CALL NO. 100  
CONTRACT ID NO. 245366  
ADDENDUM # 2

Subject: Harlan County, STP BRZ 9030 (484)  
Letting October 24, 2024

- (1) Revised - Omit Proposal Page 29 of 185
- (2) Added - Special Note - Pages 32A-32E of 185
- (3) Revised - Proposal Bid Items - Pages 184-185 of 185
- (4) Revised - Plan Sheets R1, R5, R7, S1, S4 and S13

KY-72 OVER POOR FORK CUMBERLAND RIVER  
STA. 10+70 TO 15+45

DRILLED SHAFT DETAILS  
CROSSING  
POOR FORK CUMBERLAND RIVER

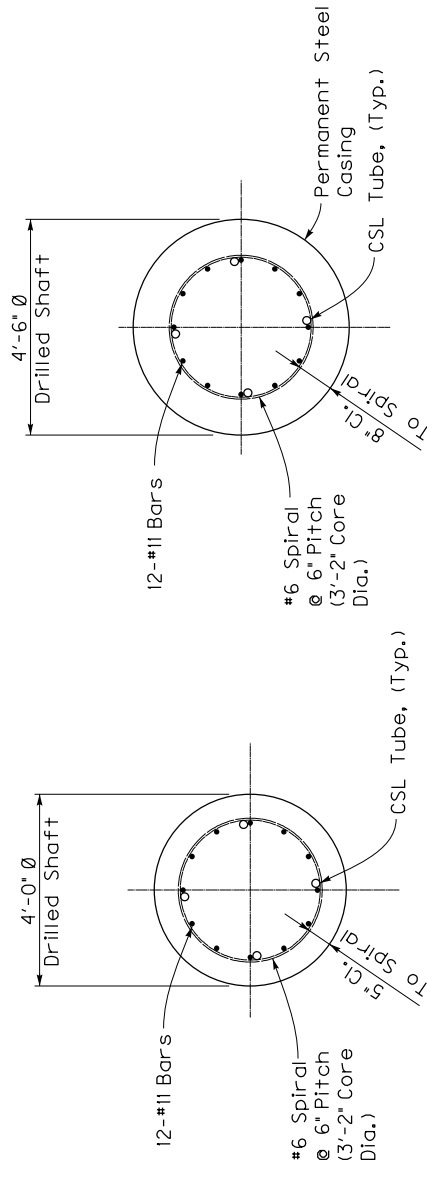
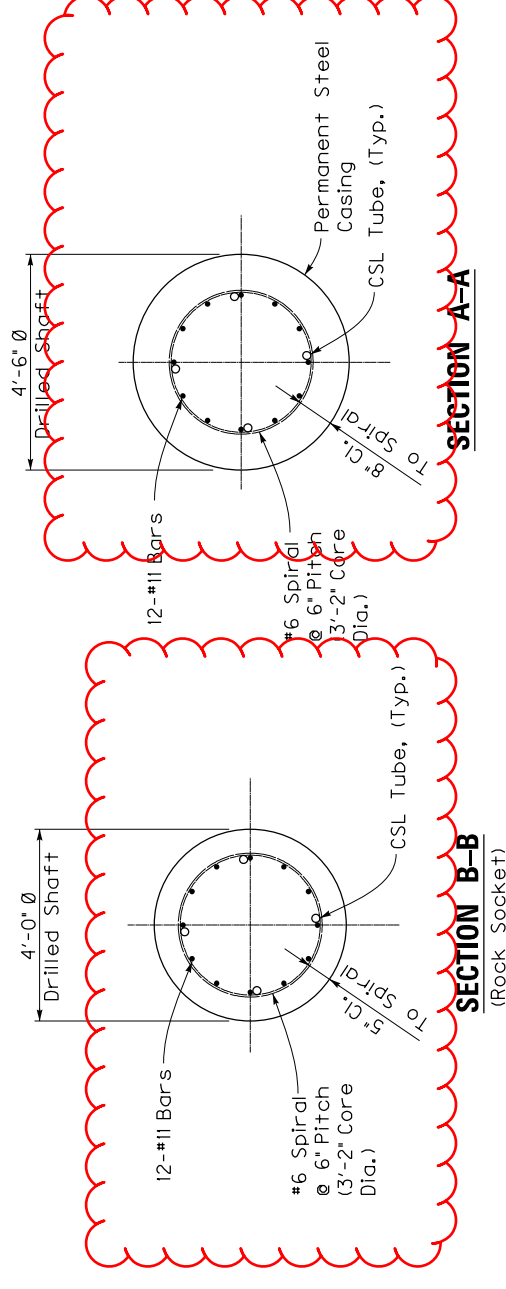
6. Integrity testing of drilled shafts is required. See the Special Note for Non-Destructive Testing of Drilled Shafts.

**SLAB PLAN**

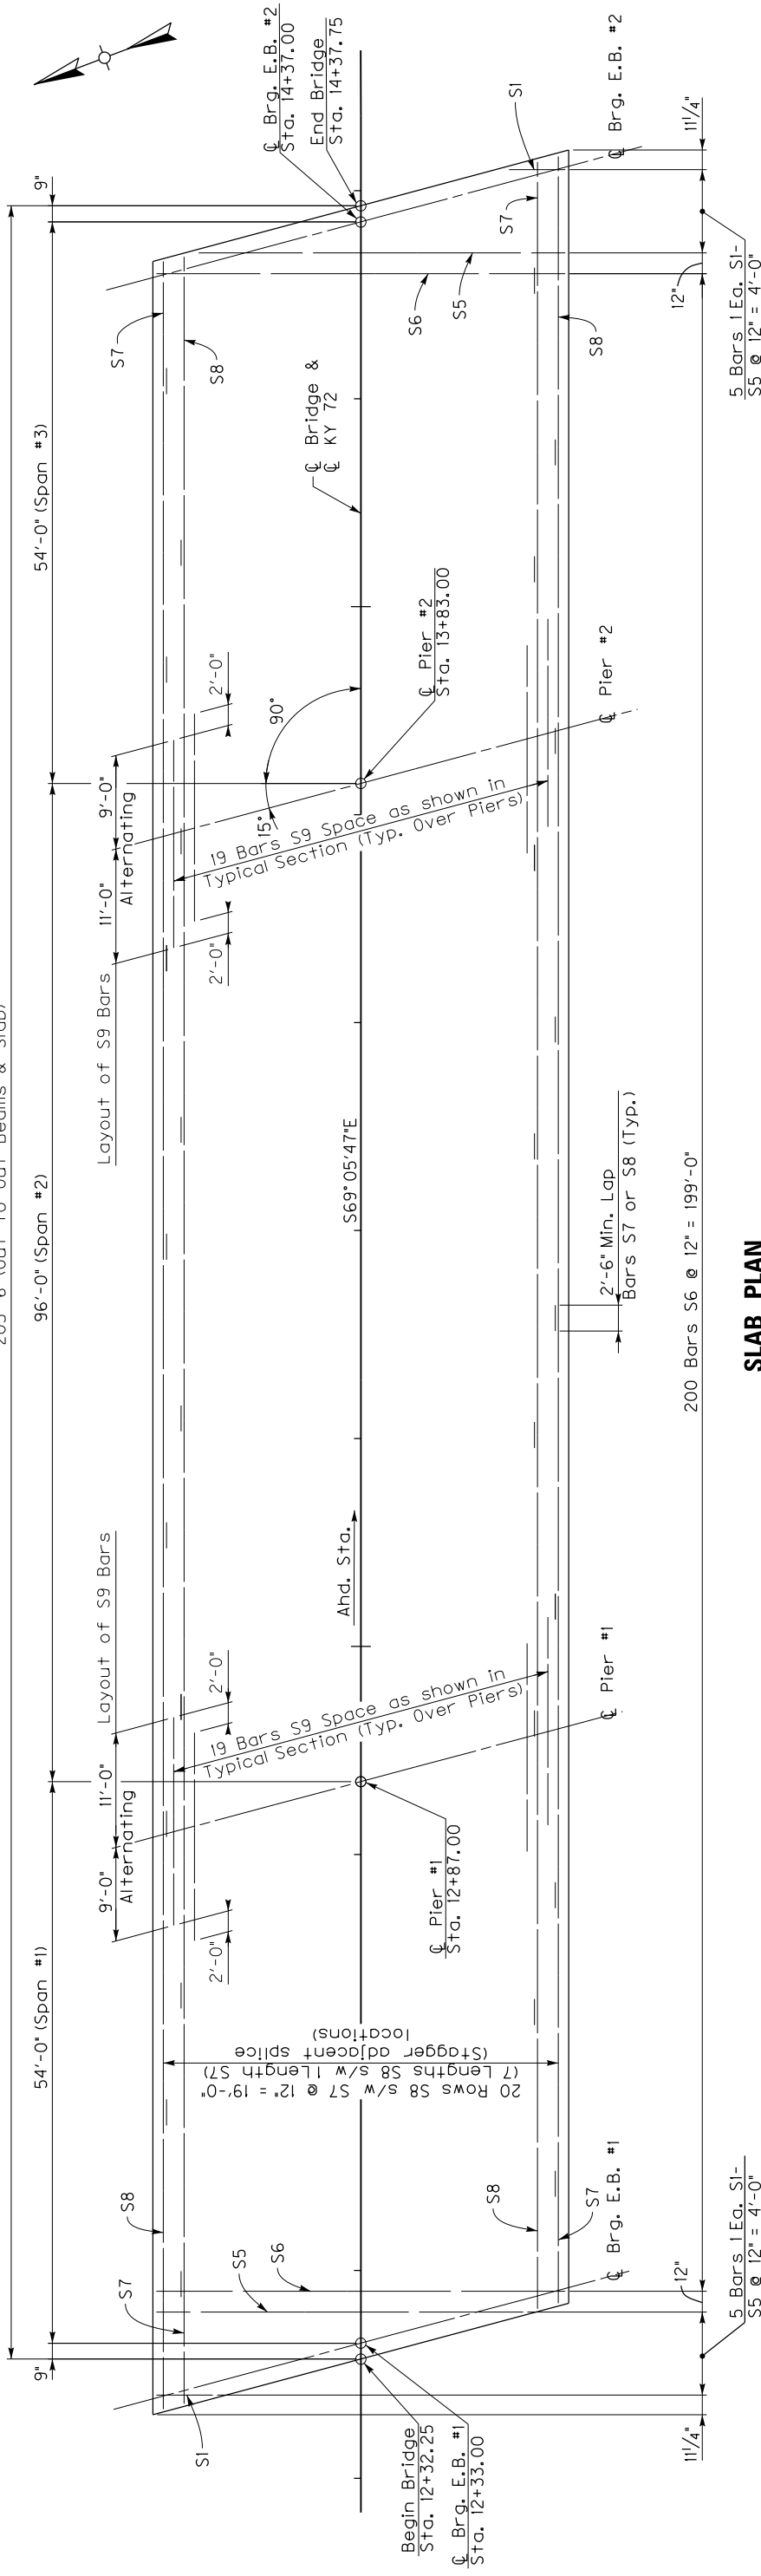
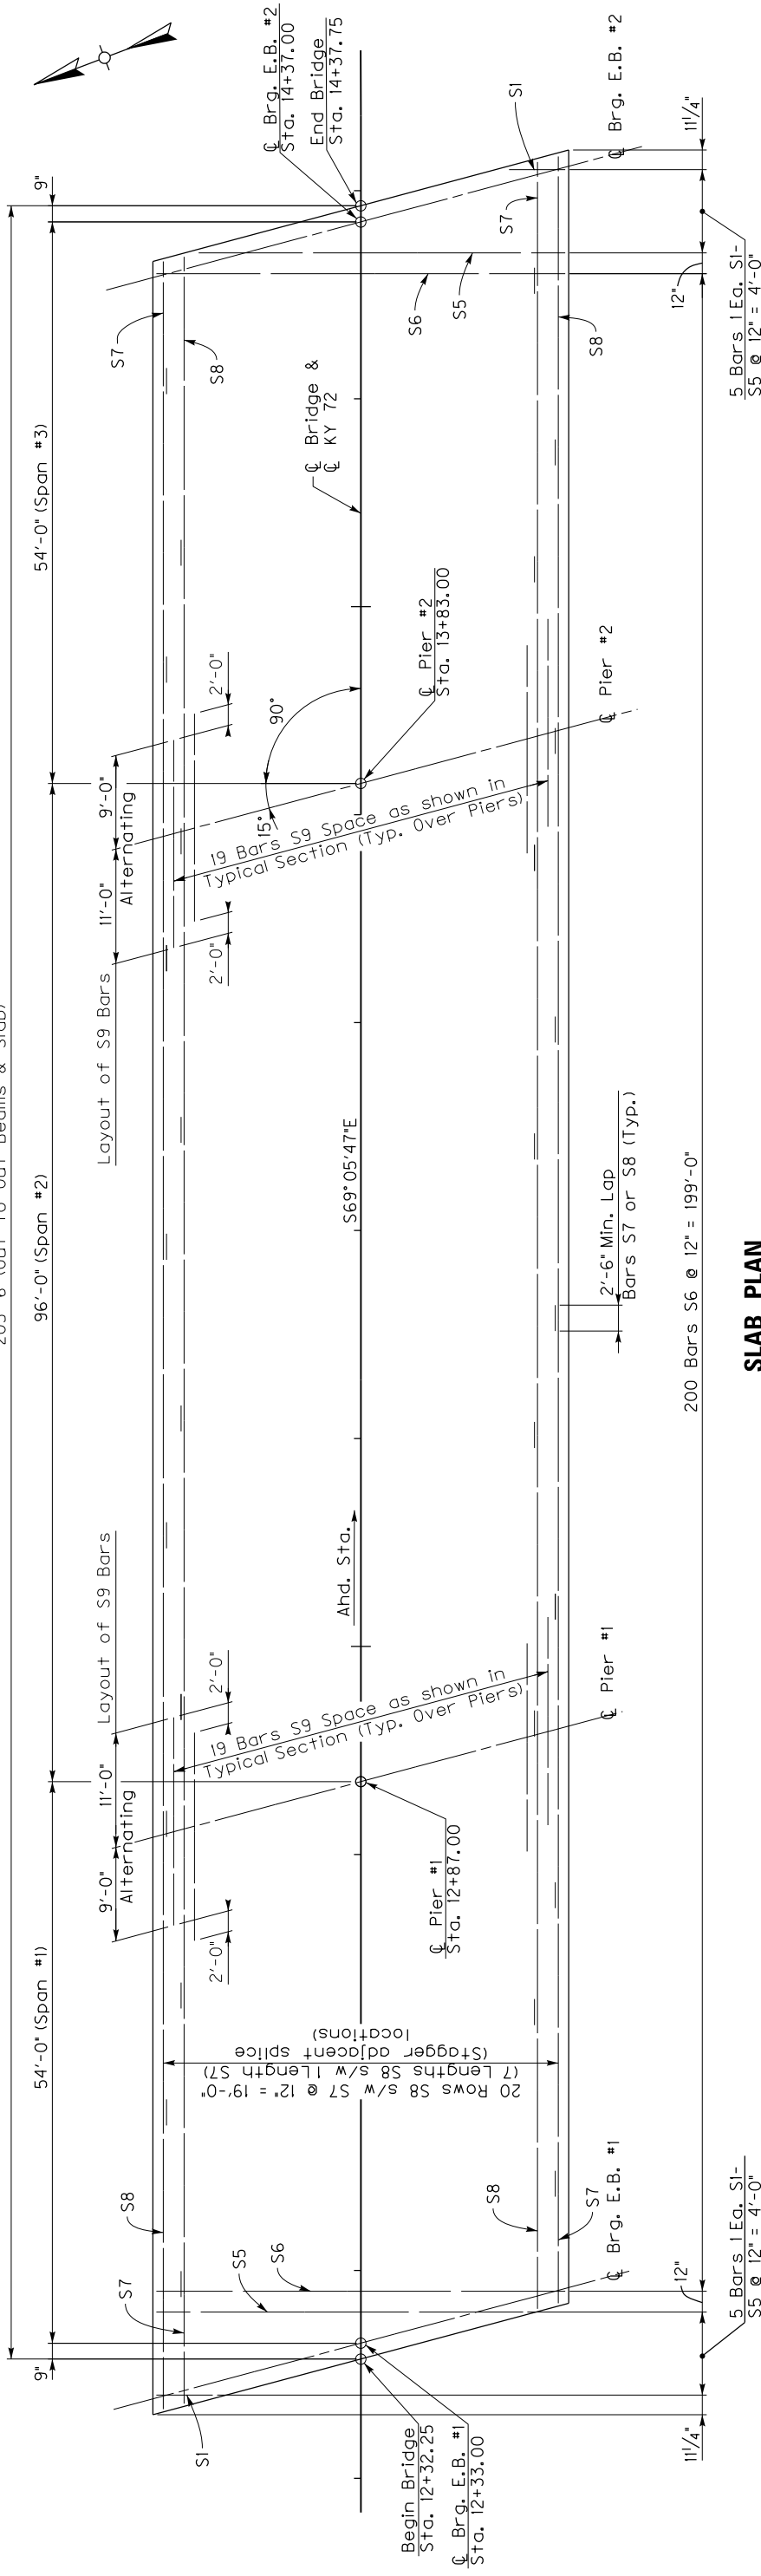
Note: Contrary to the standard drawings, the construction elevations will cause the slab to be approximately 6" thick at each end of each span and go to approximately 5" thick at the center of the span 1 & 3, and ~ 5 1/4" at the center of span 2. This is how the quantity of class "AA" concrete was calculated. Any additional concrete required above the plan quantity, due to beam camber being different from the designer's assumptions, is the contractor's responsibility and at no cost to the department.
